Brockville Main Sewage Pumping Station

ADDENDUM NO. 2

June 3, 2026

DRAWING:
WET WELL AND PUMP STATION PROCESS AND INSTRUMENTATION DIAGRAM

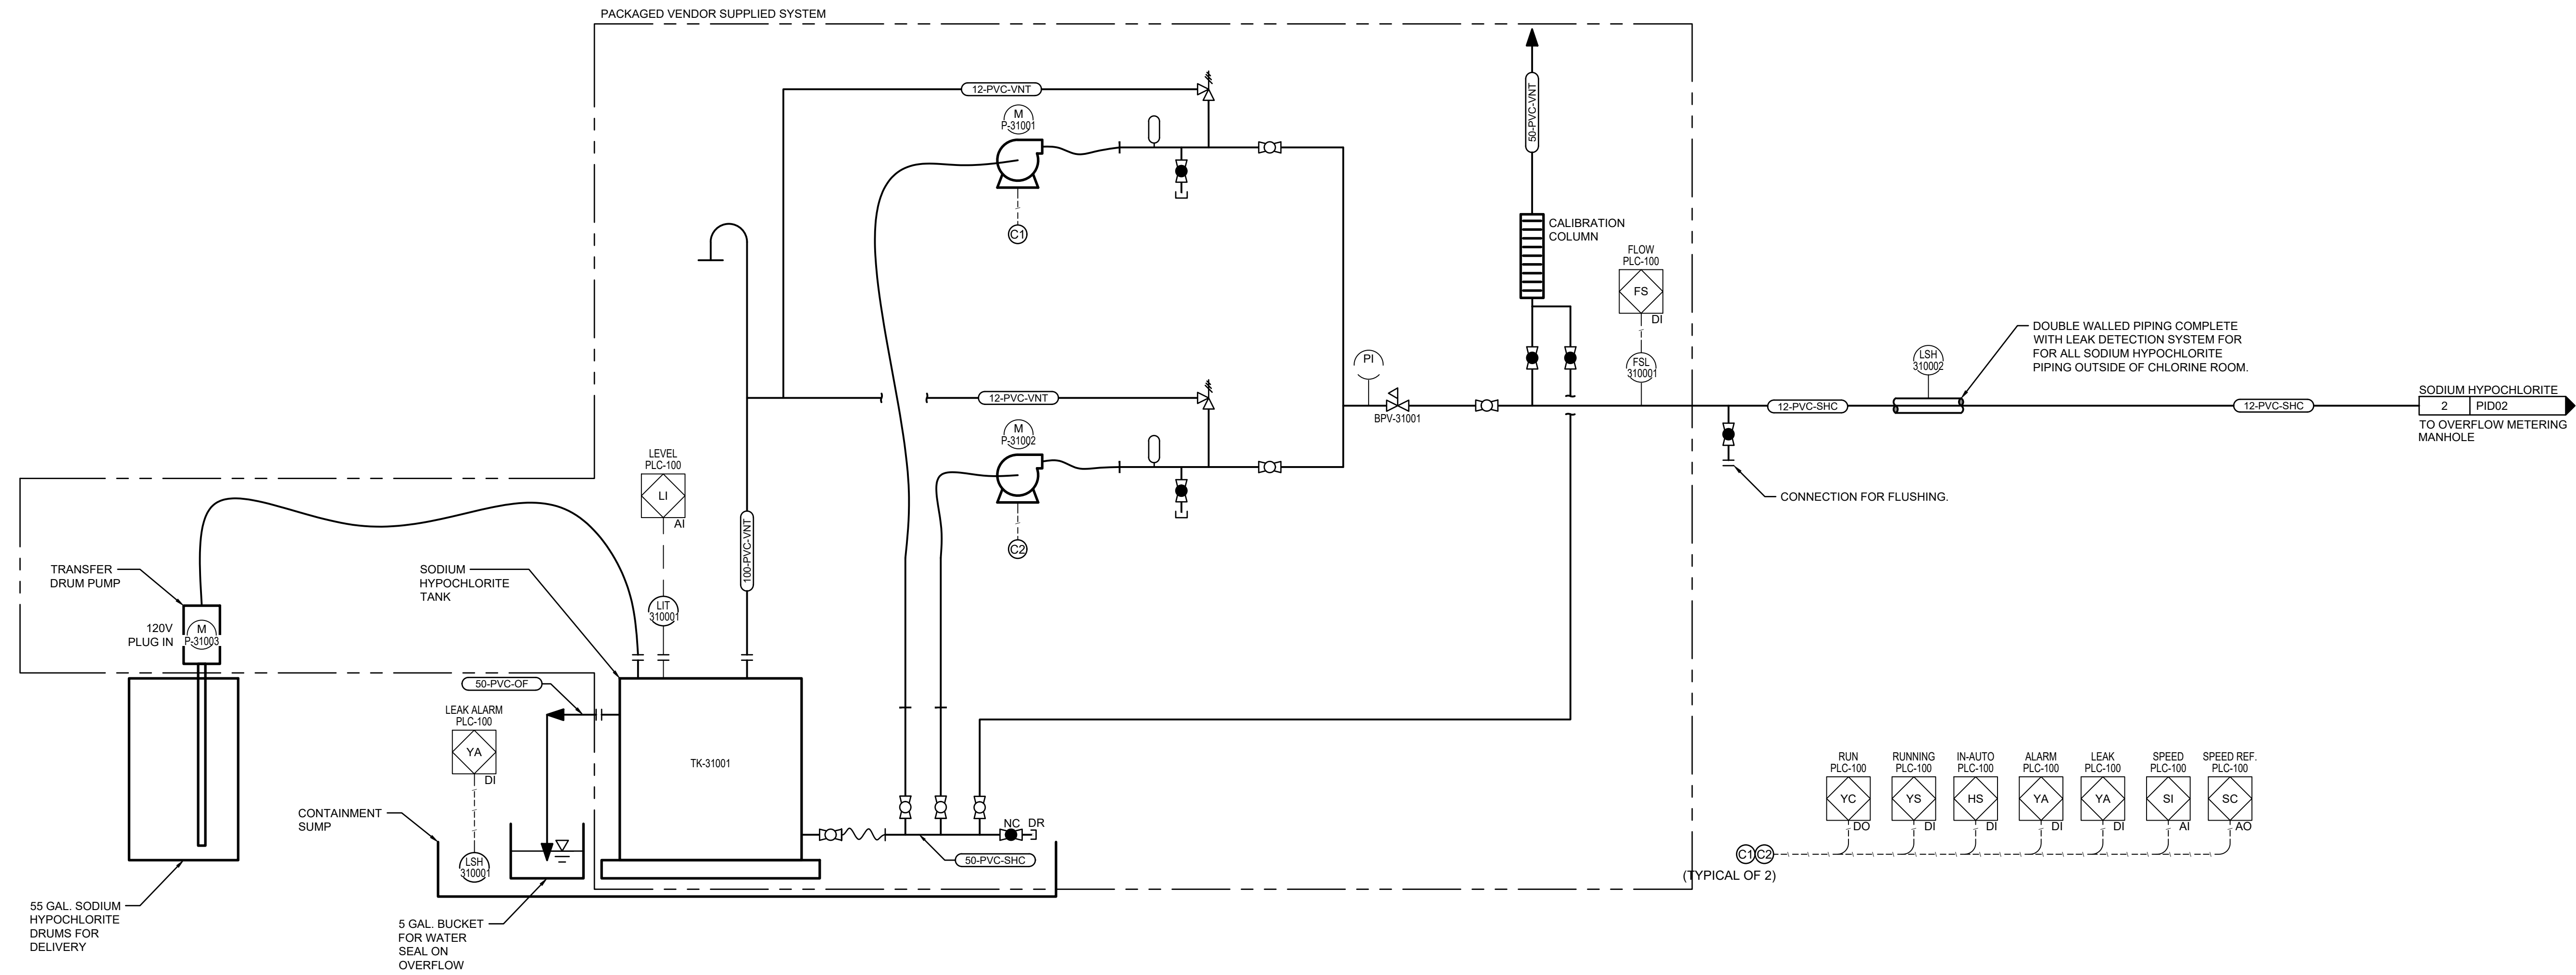
12.1 REPLACE entire drawing with the attached revised drawing PID02. Drawing revisions include the following:

- .1 ADD missing DI and AI point callout to FIT-110001. To align with existing I/O list.
- .2 REPLACE ALL I/O PLC tags from CP-100 to PLC-100.

DRAWING: SINGLE LINE DIAGRAM

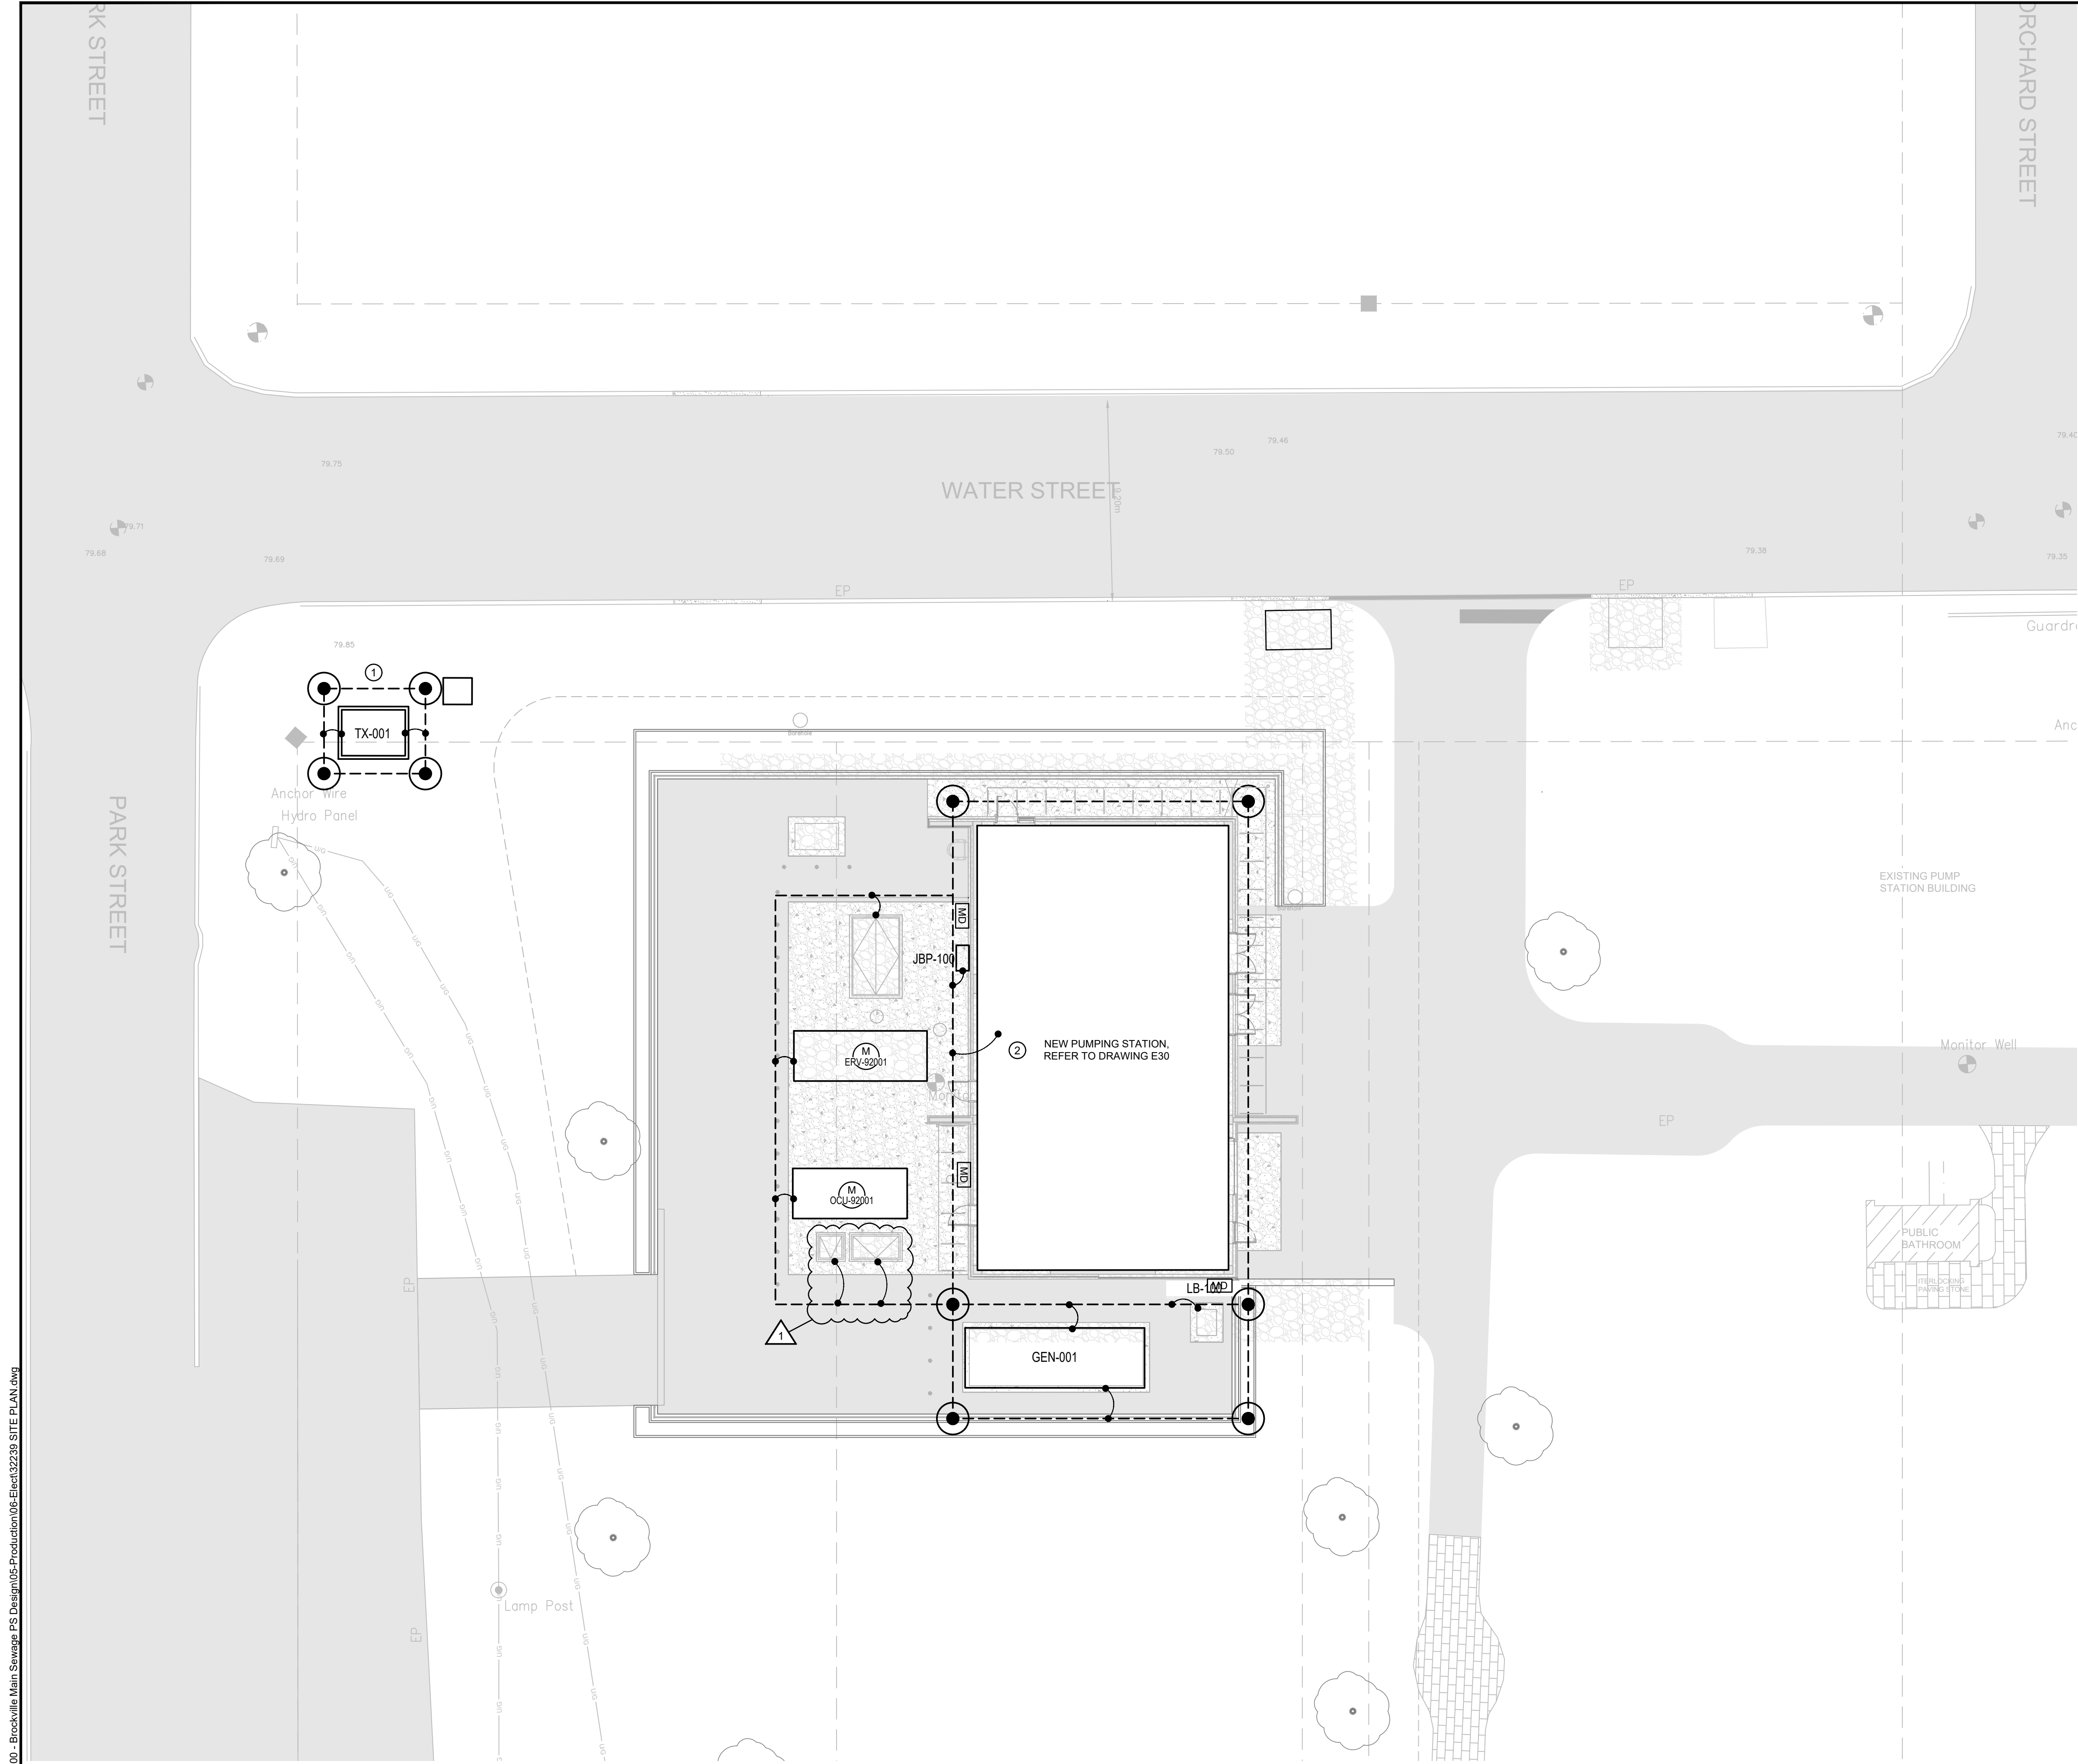
Item No. 18 Drawing E10 (Single Line Diagram)

18.1 REPLACE entire drawing with the attached revised drawing E10. Drawing revisions include the following:

1 ELECTRICAL GROUNDING PLAN
 E21
 SCALE: 1:150

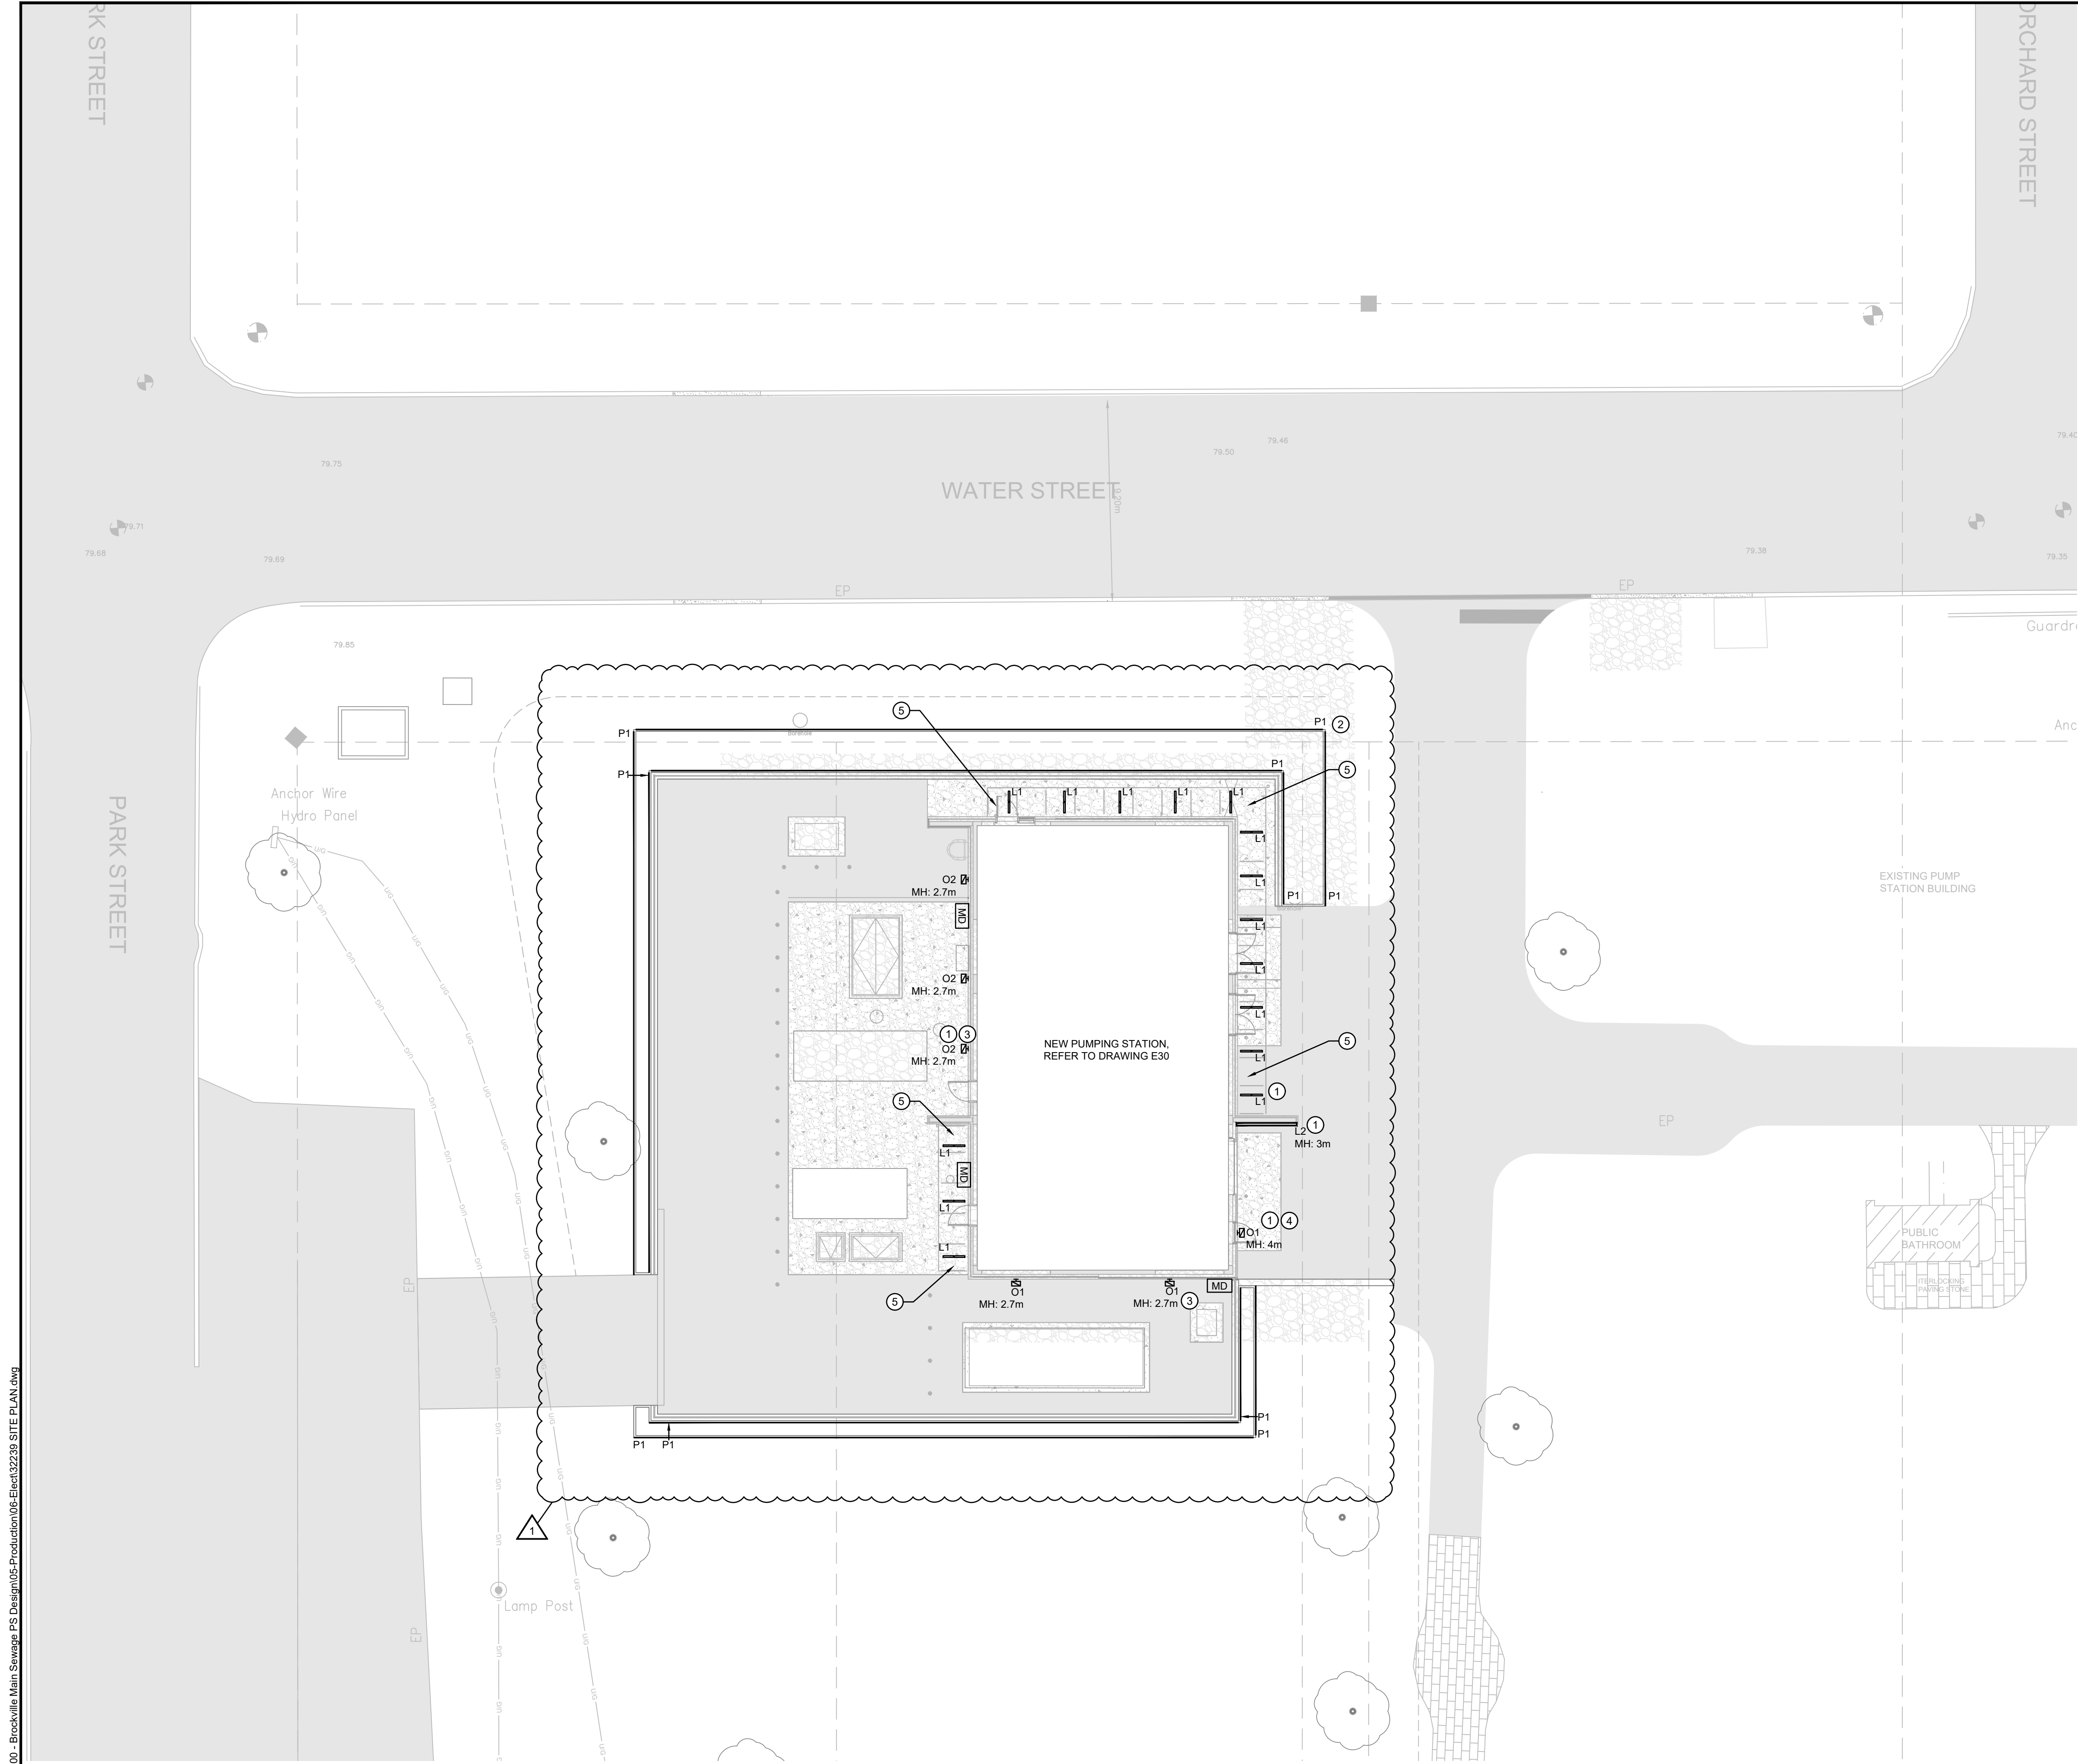
19.1 REPLACE entire drawing with the attached revised drawing E21. Drawing revisions include the following:

- .1 ADD bonding jumpers to wet well hatches to align with drawing E12 Grounding diagram requirements.
